Product Bulletin:

October 17, 2023

Subject: Rear Door Lock Rods

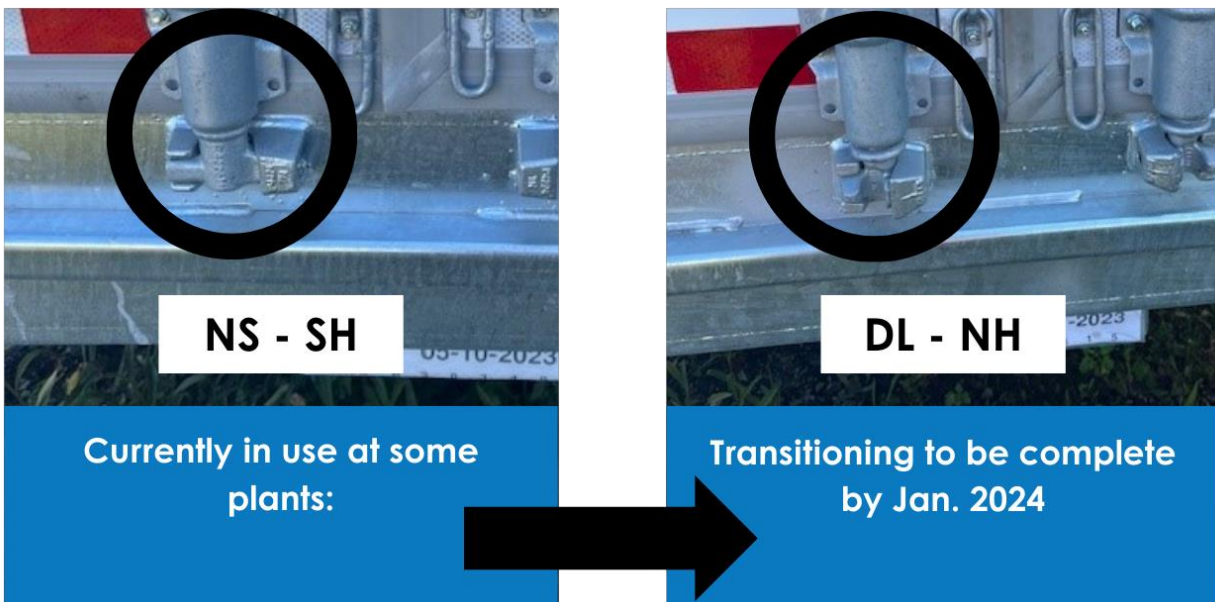
Stoughton Trailers is simplifying the door lock rods across our dry van product line. Currently, we have a combination of lock rods styles on our swing door dry vans, using both styles NS-SH and DL-NH. We are implementing a running change to use exclusively DL-NH in the future. By January of 2024 we expect to be fully converted to DL-NH at all of our dry van manufacturing plants. Many customers prefer to the DL-NH style as the design allows for the toe to get a better fit within the keeper, which makes it easier to secure the door in the closed position.
